Docket: *Exelon Generating Company, LLC* (Early Site Permit for the Clinton ESP Site), Docket No. 52-007

Re: Response to NRC Request for Additional Information (RAI) Related to Contention 3.1

Subject: Exelon Generation Company, LLC (EGC), Response to Requests for Additional Information (RAI) regarding the Environmental Portion of the Application for an Early Site Permit (ESP) (TAC NO. MC1125)

Re: Letter, U.S. Nuclear Regulatory Commission (T. J. Kenyon) to Exelon Generation Company, LLC, (M. Kray), dated August 23, 2004, Request for Additional Information (RAI) Regarding the Environmental Portion of the Early Site Permit Application for the Exelon Generation Company Site (TAC NO. MC1125)

Insert new Figure 9.2-4, Direct Normal Solar Radiation Map:

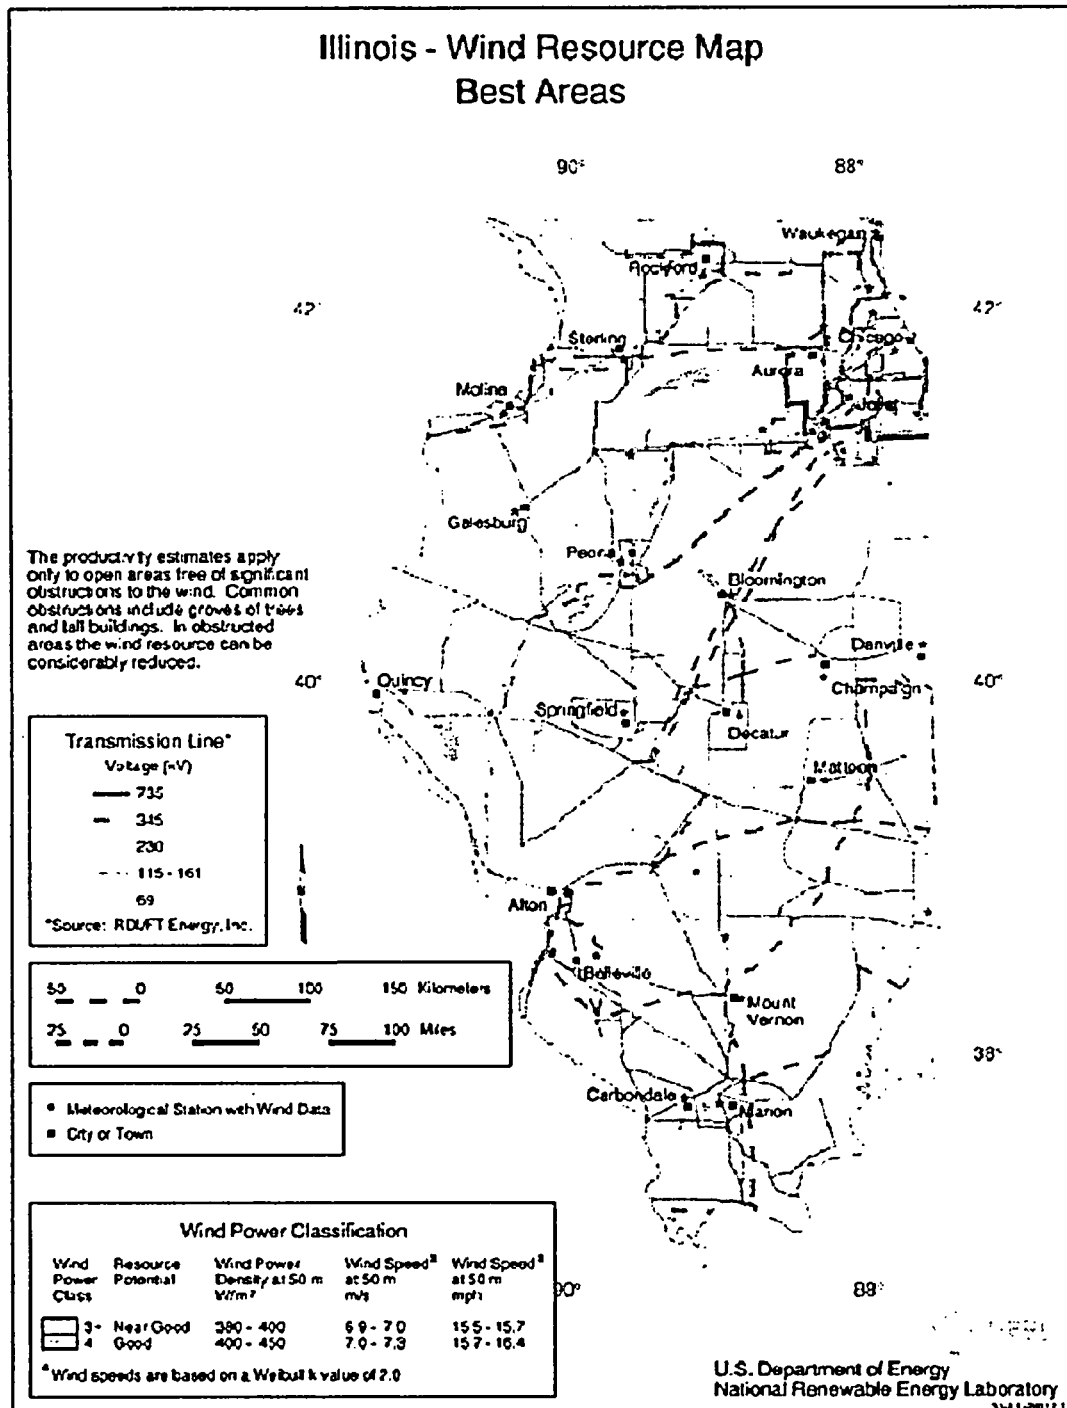
E9.2-1 In its August 6, 2004, Memorandum and Order, the Atomic Safety and Licensing Board for the Exelon early site permit application admitted the following contention:

CONTENTION: The Environmental Review fails to rigorously explore and objectively evaluate all reasonable alternatives. In Section 9.2 of the Environmental Report, Exelon claims to satisfy 10 CFR 51.45(b)(3), which requires a discussion of alternatives that is "sufficiently complete to aid the Commission in developing and exploring" "appropriate alternatives concerning alternative uses of available resource," pursuant to the National Environmental Policy Act. However, Exelon's analysis is premised on several material legal and factual flaws that lead it to improperly reject better, lower-cost, safer, and environmentally preferable wind power and solar power alternatives, and fails to address adequately a mix of these alternatives along with the gas-fired generation and "clean coal" resource alternatives. Therefore, Exelon's ER does not provide the basis for the rigorous exploration and objective evaluation of all reasonable alternatives to the ESP that is required by NEPA.

Provide information to address this contention.

EGC has addressed the issues raised in the Contention. As a result, ER, Chapter 9, Section 9.2.2.1, Wind, Section 9.2.2.4, Solar, Section 9.2.4, Conclusion, Table 9.2-6, Impacts Comparison Summary, Table 9.2-7, Impacts Comparison Detail, and References for Section 9.2 will be revised. Section 9.2.3.3, Combination, Figure 9.2-3, Illinois Wind Resource Map, and Figure 9.2-4, Direct Normal Solar Radiation Map will be inserted.

In Illinois, solar energy varies from 4-5 kWh/m²/day in the summer to as low as 2-3 kWh/m²/day the winter. (See Figure 9.2-4). The areas with the highest amount of solar radiation are in the southwestern part of the state, with radiation rates of 6 - 7 kWh/m² at the brightest time of a summer day, but most of Illinois falls in the range of 5.5 - 6 kWh/m². This resource is relatively low, particularly when compared to the southwestern United States. For example, parts of southern California can generate 10 - 12 kWh/m² of solar radiation during the brightest part of summer days. From a national resource availability perspective, then, it can be seen that the region of interest is not an attractive location for development of solar power. In addition to the relatively low amount of solar resource available, solar radiation varies by month (USDOE/NREL, 2004c). Solar energy also has a definite diurnal characteristic-the sun does not shine at night. Recognizing the comparative "abundance" of solar energy in the region of interest and the intermittent nature of solar-based electricity generation, various solar technologies are discussed below.
